## SIB 61 14 12

### Recall Campaign 12V-126: Check the Battery Cable Connection

This Service Information Bulletin (Revision 1) replaces SI B61 14 12 **dated April 2012**.

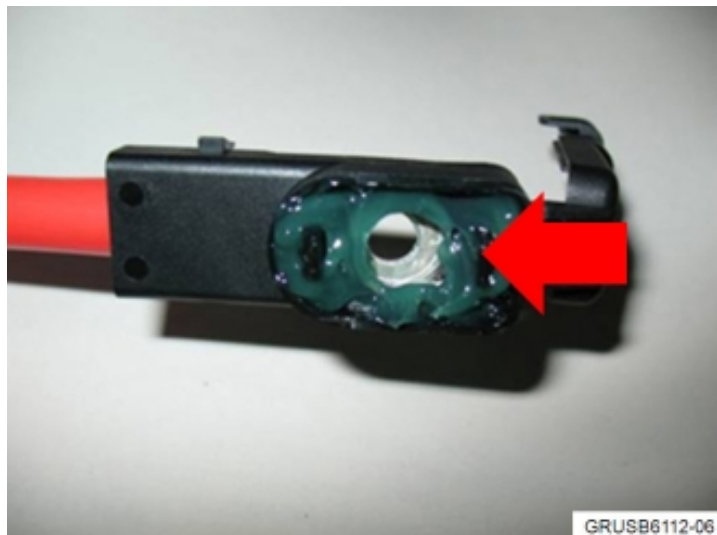
5. Open the cover (1) of the battery cable (3) connecting screw lug and remove the securing bolt (2).

6. Check that both clip-retaining tabs are locked into the luggage compartment sheet metal. If not, proceed to the next step.

7. Screw the previously removed securing bolt into the lug and pull up, so that both retainers on the clip are locked into the sheet metal.

8. Coat the area around the lug covering the retaining clip with contact protection grease.

GRUSB6112-06

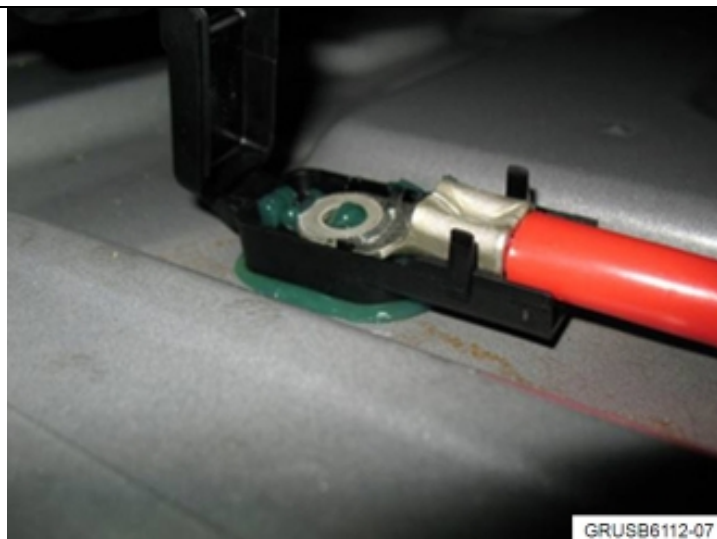
9. Ensure that the cable is clean before assembly. Install the new battery positive terminal cover (**the new cover is white in color**) and coat the bottom area, as shown, with contact protection grease.
